SERVICE BULLETIN

Subject: Cyclic Balance Adjustment with Single or Dual Controls Configuration

Helicopters Affected: Bell 407 with an Onboard Systems Dual Cargo Hook System installed per STC SR02724LA.

Figure 1 – Existing Installation for 407GX and 407GX with AFCS Provisions Kit Configuration

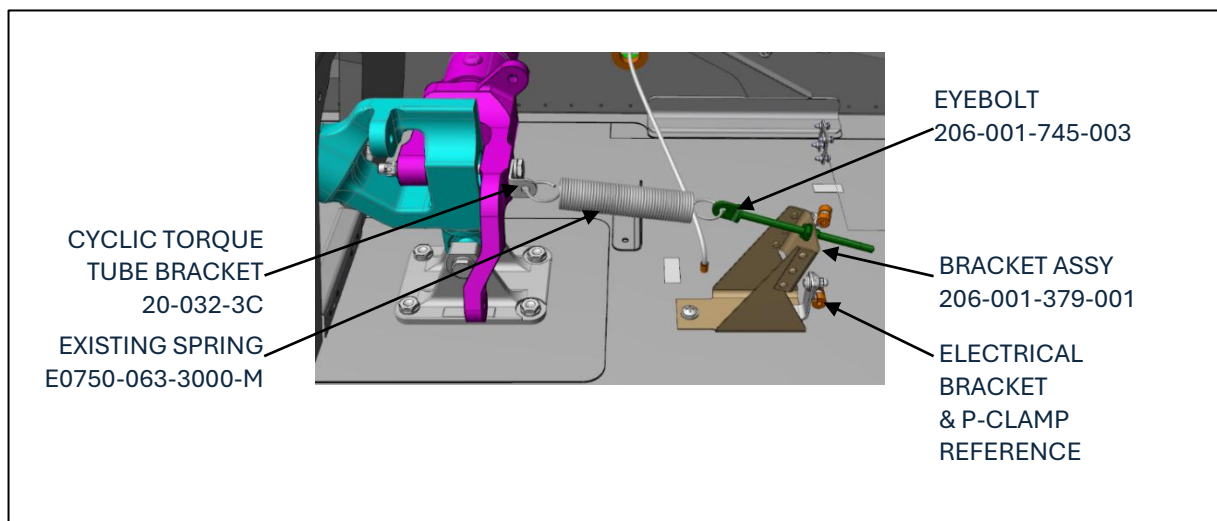
- a. Remove the existing trim control spring (P/N E0750-063-3000-M for 407GX and 407GX with AFCS Provisions Kit or P/N 206-001-402-001 for 407 and 407GX without the AFCS Provisions Kit) from the Eyebolt (P/N 206-001-745-003). See Figure 1.
- b. Remove and retain the Bracket Assembly (P/N 206-001-379-001) and the Eyebolt (P/N 206-001-745-003). See Figure 1.
- c. Temporarily relocate the electrical bracket and P-clamp attached on the aft screw. Retain screws and washers (QTY 2).
- d. **For Model 407GX with the AFCS Provisions Kit installed and Model 407GX:**

Figure 2 – Modifications for 407GX and 407GX with AFCS Provisions Kit Configuration

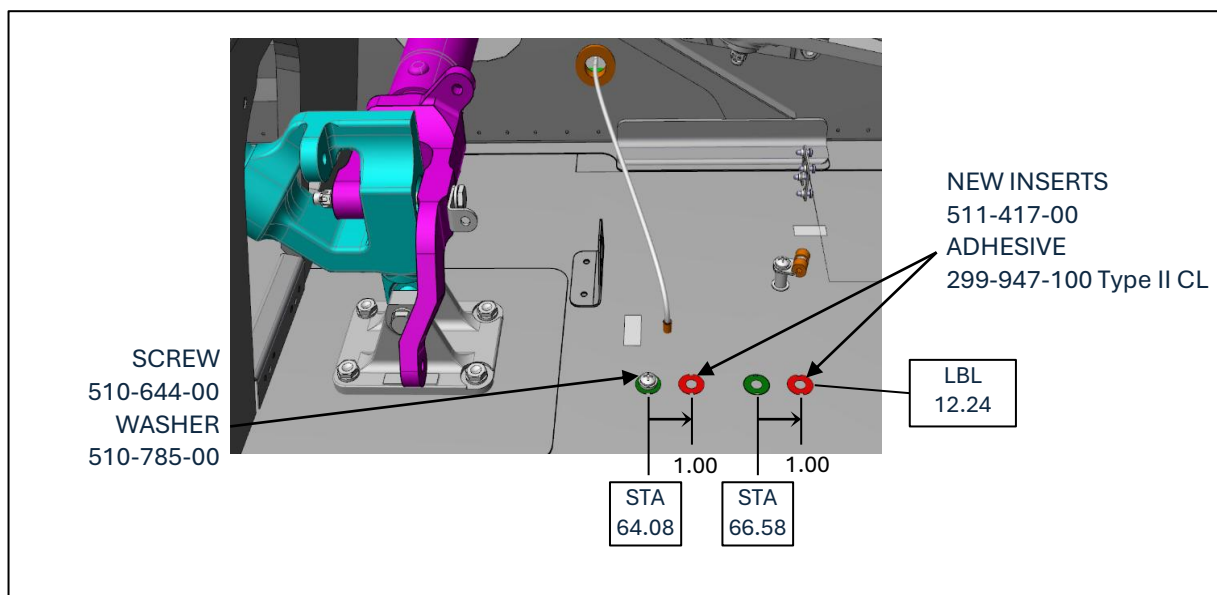
Install QTY 2 new inserts (P/N 511-417-00) at STA 65.08 and 67.58. The new inserts shall be 1.00" aft of the current inserts at STA 64.08 and 66.58. Drill .562/.565" holes through the inner skin and core. Add adhesive (P/N 299-947-100 Type II CL 2) to retain the inserts. See Figure 2.

- f. Plug the visible insert located at STA 64.08 (407GX with AFCS Provisions Kit or 407GX) or STA 69.08 (407 or 407GX without AFCS Provisions Kit) with a screw (P/N 510-644-00) and washer (P/N 510-785-00) as seen in Figure 2.

Please note: Model 407 and 407GX without AFCS Provisions Kit baseline inserts are not located at STA 64.08 and 66.58 as shown. The baseline inserts for Model 407 and 407GX without AFCS Provisions Kit are located at STA 66.58 and 69.08.
